CITY of NOVI CITY COUNCIL

Agenda Item 3
September 24, 2018

SUBJECT: Approval of the request of Cambridge of Novi, LLC, for Villa D'Este, JSP17-52, with Zoning Map Amendment 18.718, to rezone from RA (Residential Acreage) to R-1 (One-Family Residential), subject to a related Planned Rezoning Overlay (PRO) Agreement, and corresponding PRO Concept Plan. The property is approximately 50.6 acres and is located east of Napier Road on the north side of Nine Mile Road. The applicant is proposing a 41-unit single-family housing development in a gated community.

SHEET 2

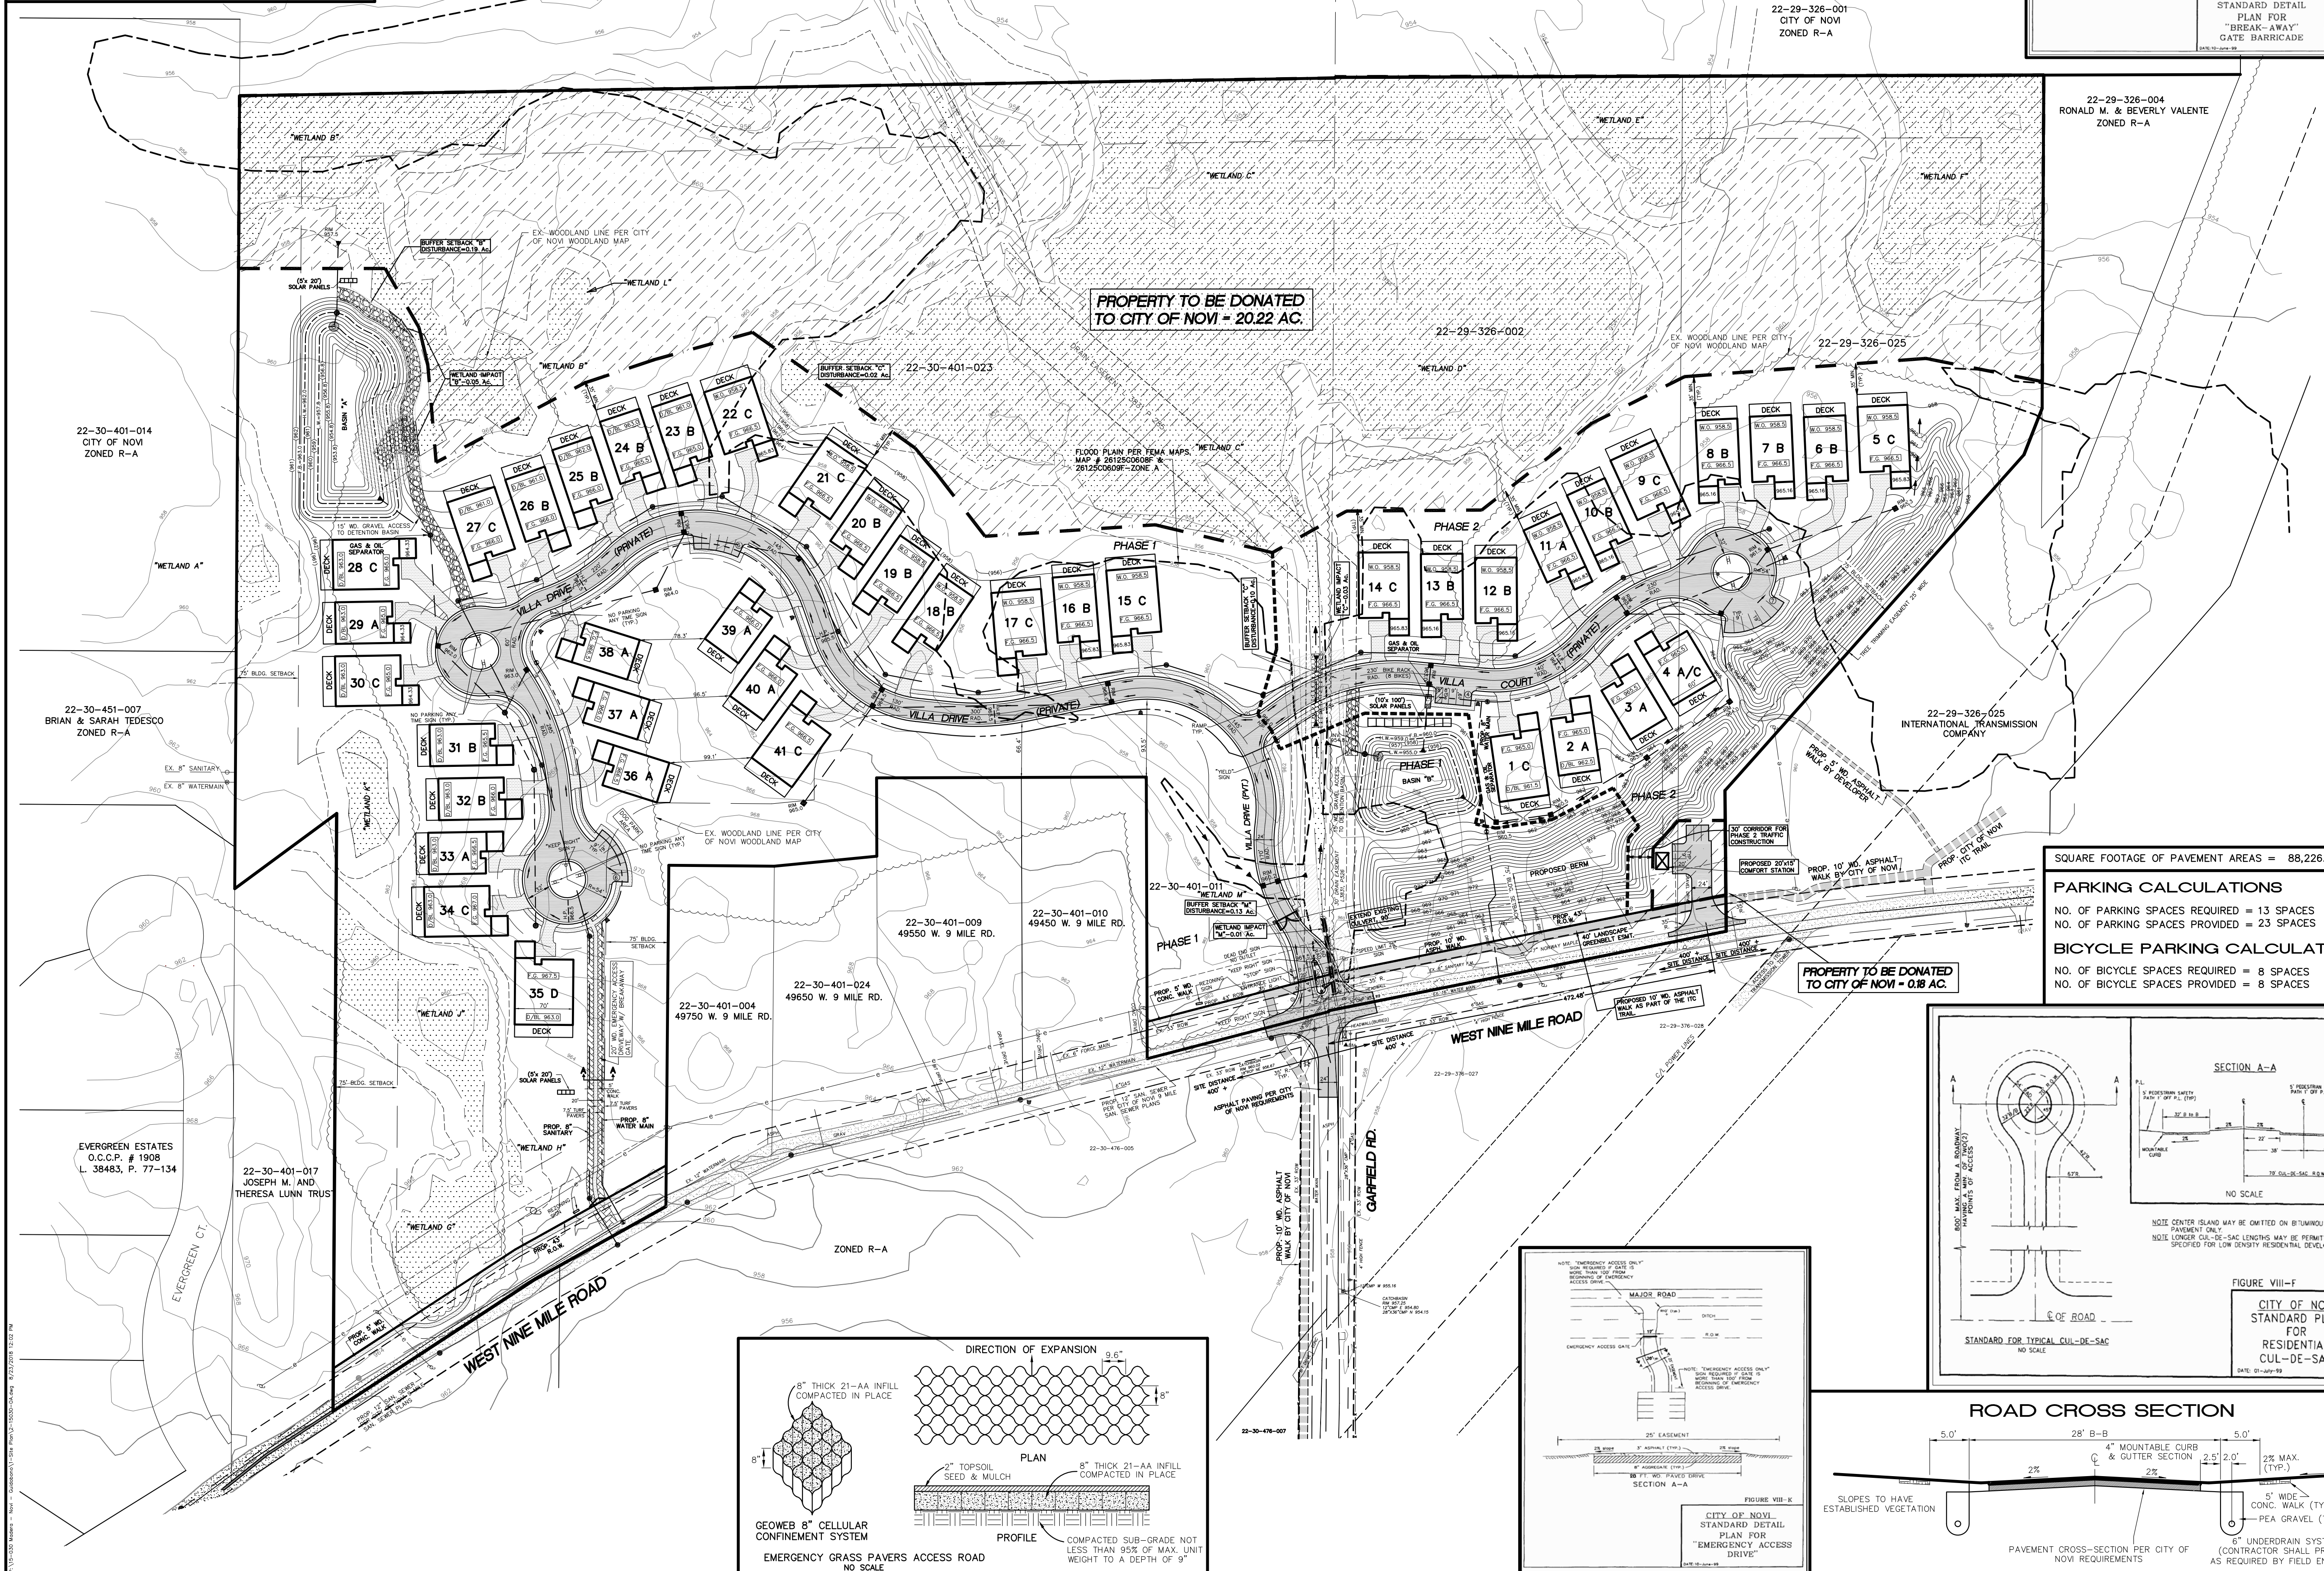
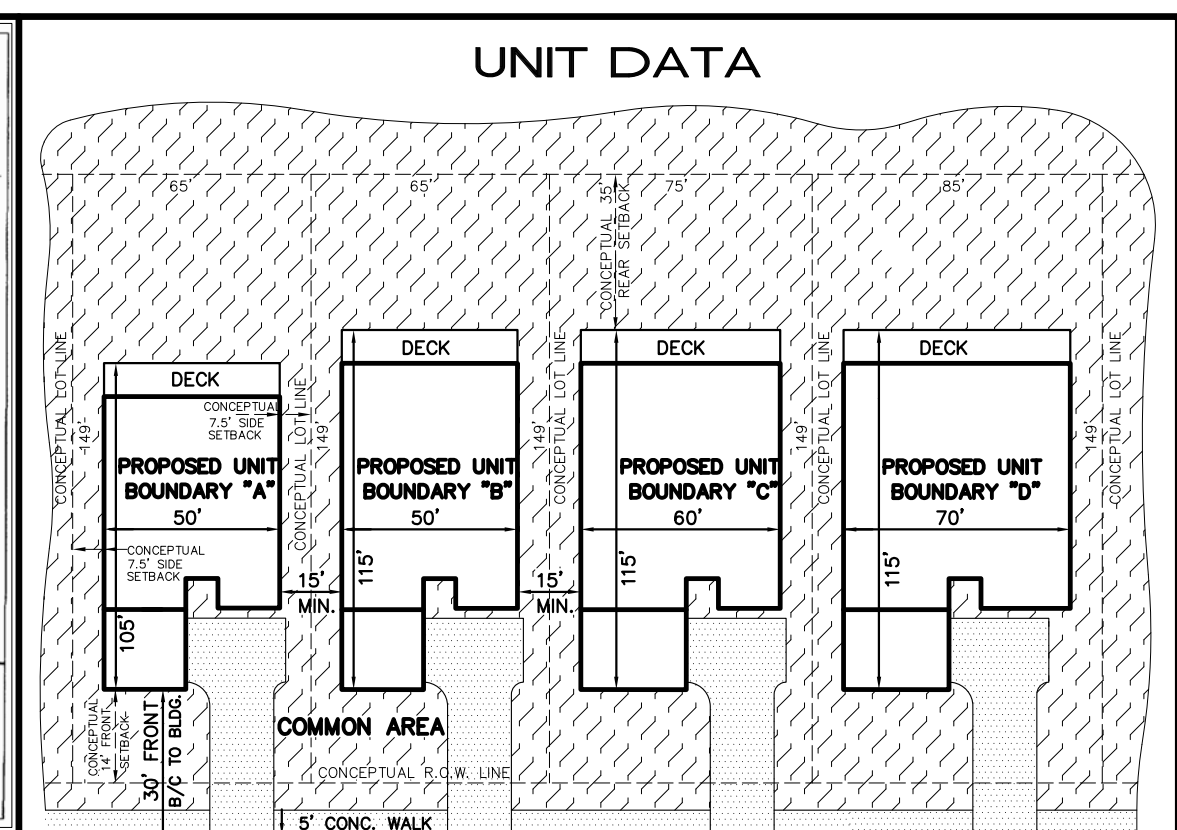
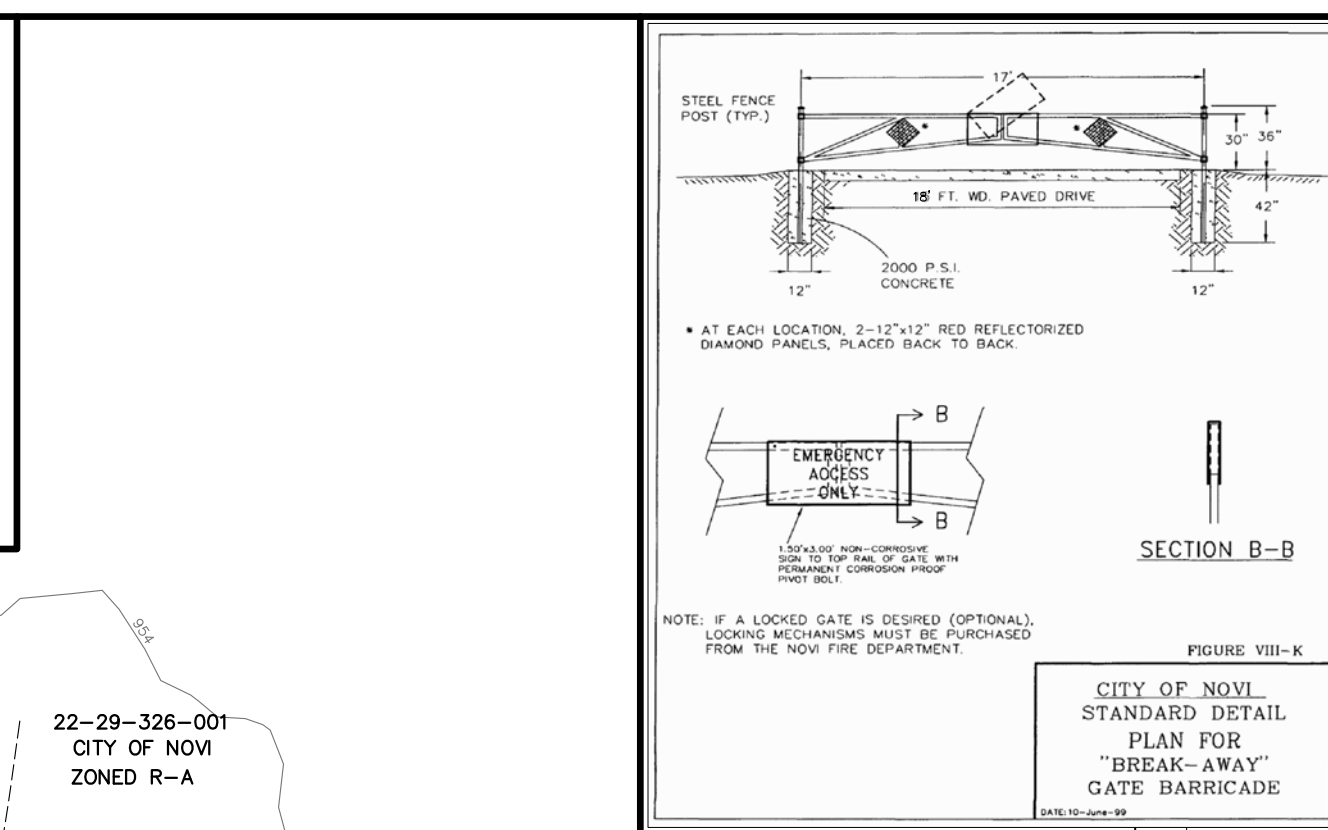
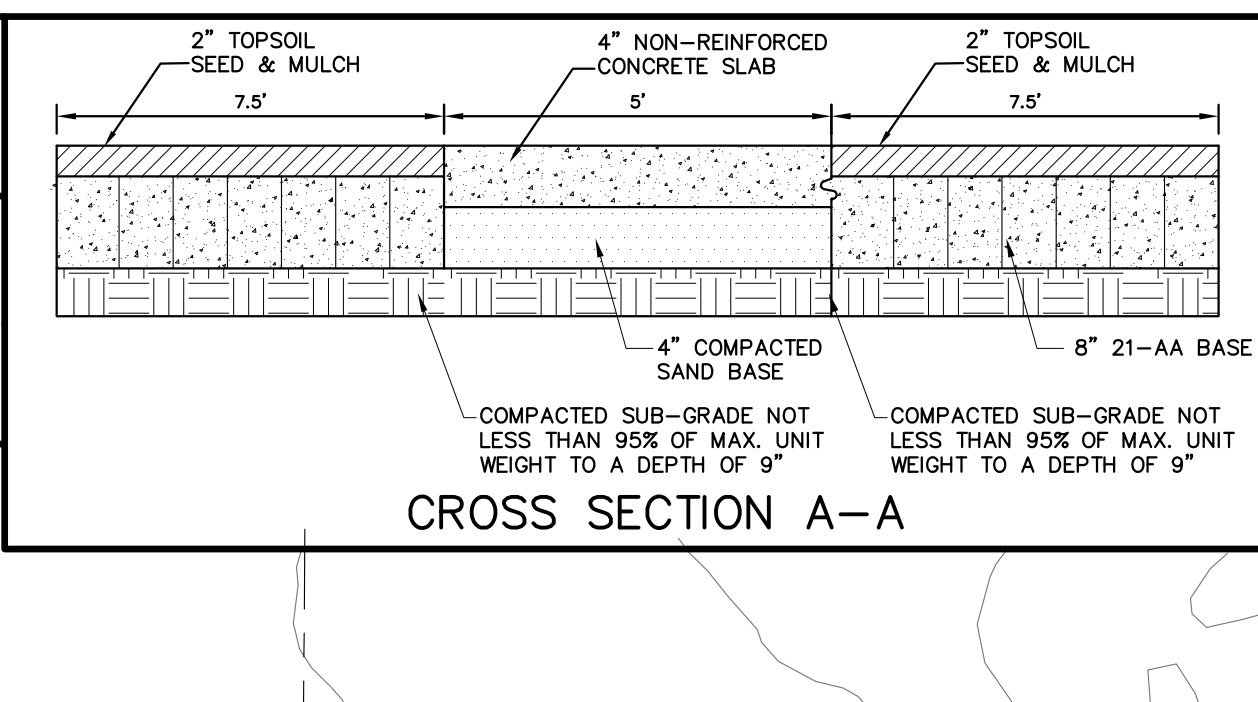
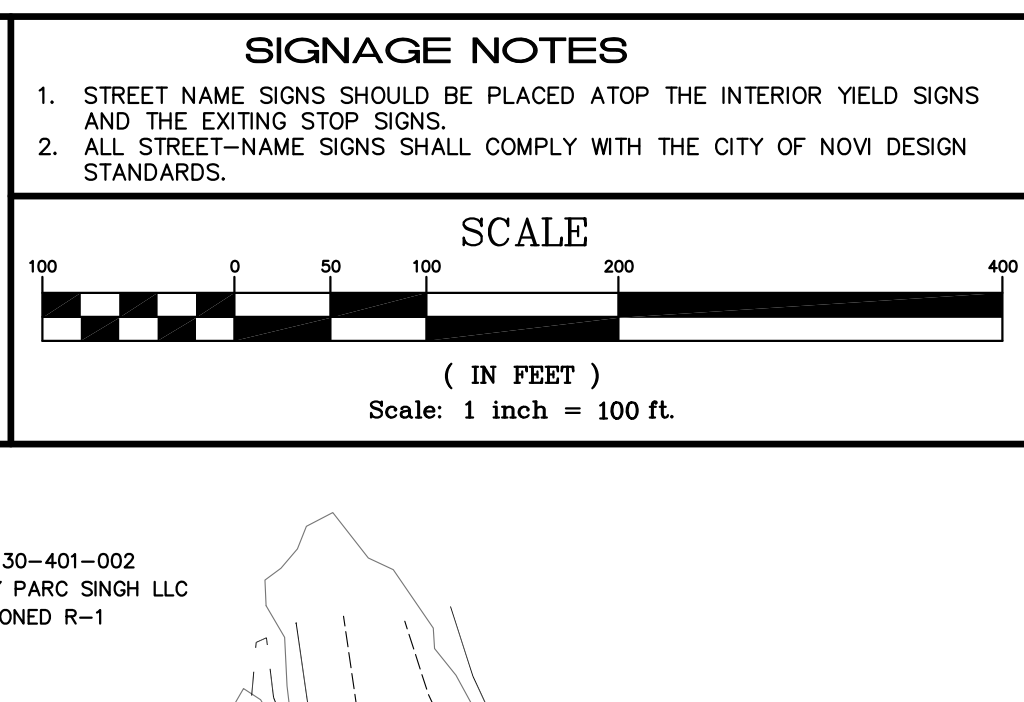
5. **The Unit Data sketch on Sheet 2 shows common area, and unit boundaries for clarification in the Master Deed.** *The note indicates that "Allowable Uses in Limited Common Element Area (at rear and side only) could include fire pits, fireplaces, hot tubs, pools, patios, sidewalks, decks, gardens and related appurtenances. Setbacks for these items to comply with R-1 Zoning Setbacks". The submitted response letter dated August 13, 2018 further indicates that certain units have expanded side yards for the listed uses. The applicant has indicated that the uses proposed must be approved by the developer. Staff notes that the location of such items shall be subject to all relevant codes and ordinances, as well as with any language provided in the Master Deed. Language association with such approvals shall be approved by the City Attorney as a part of the PRO Agreement and Master Deed, and any other related documents.*

- v. Sheet 2 "Proposed Improvements" note 5 should be updated to indicate 10' wide asphalt walk, instead of 8' east of Garfield Rd. The proposed walk west of the development driveway shall be 6' per note above.

2. Revise the Emergency Access Drive profiles and details on sheets 2 and 3 to be consistent with the plan view which shows a 5-foot walk centered on the 20-foot emergency access drive.

- a. Revise the Concept plan to indicate 6-foot sidewalk on Nine Mile Road.
 - b. Revise Note 5 on sheet 2 to indicate 10-foot asphalt path instead of 8-foot asphalt path, and include the 6-foot sidewalk in the notes.

It should be noted that the Wetland Impact table on the Plan indicates the impact area to the Wetland C buffer is 0.10-acre. The note in the plan view (i.e., Sheet 2) indicates two (2) impacts to the Wetland C buffer of 0.02-acre and 0.10-acre (totaling 0.12-acre). This quantity shall be clarified on the Plan and Wetland Impact Table.
